Submittal No.: 05c: Traffic Control Plan Revised

**Description:** Proposal/Contract Number: Windsor-Hartford IM BPNT (13)  
Letting Date: 10/09/15; Award Date: 11/02/15  
Project Description: Bridge Painting of Eleven Bridges  
In the Towns of Windsor & Hartford, Windsor County, VT  
Contract Amount: \$8,671,323.00; Completion Date: 10/12/18

# TRAFFIC CONTROL PLAN

## WINDSOR – HARDFORD IM BPNT (13)

STANDARD  
T-11  
MODIFIED

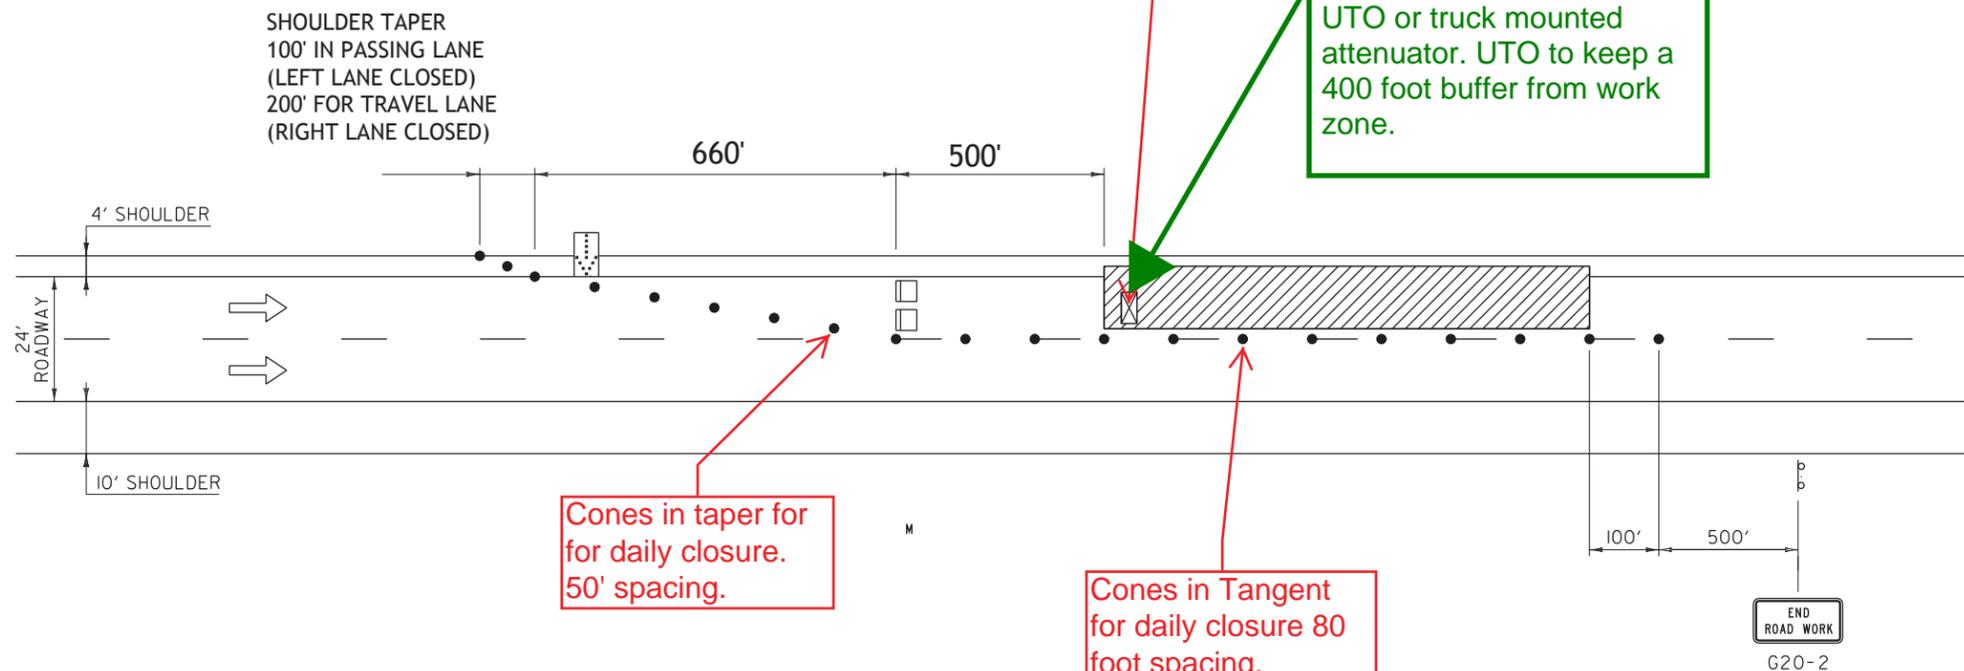
Why no truck mounted attenuator or UTO?

No truck mounted attenuator.

STANDARD  
**T-12**  
 Modified

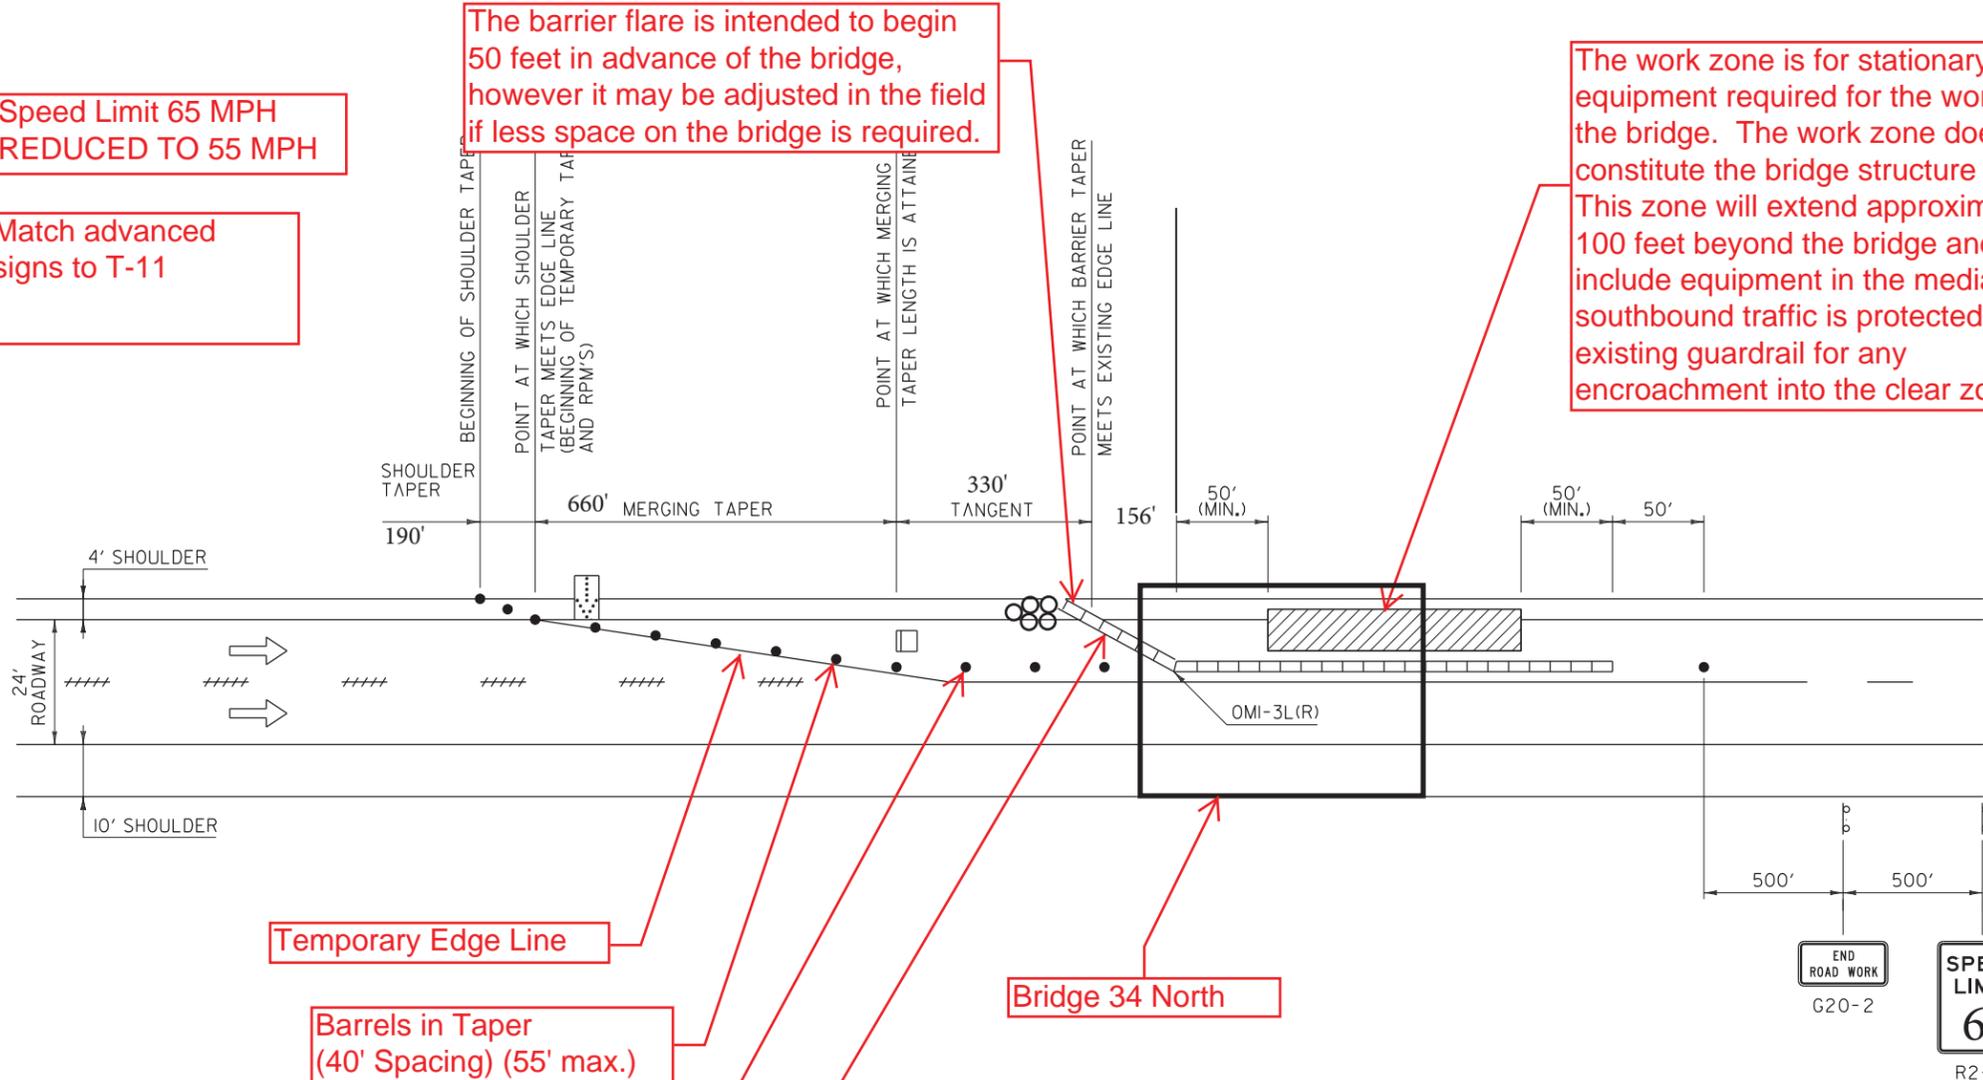
Match advanced  
signs to T-11

The barrier flare is intended to begin 50 feet in advance of the bridge, however it may be adjusted in the field if less space on the bridge is required.
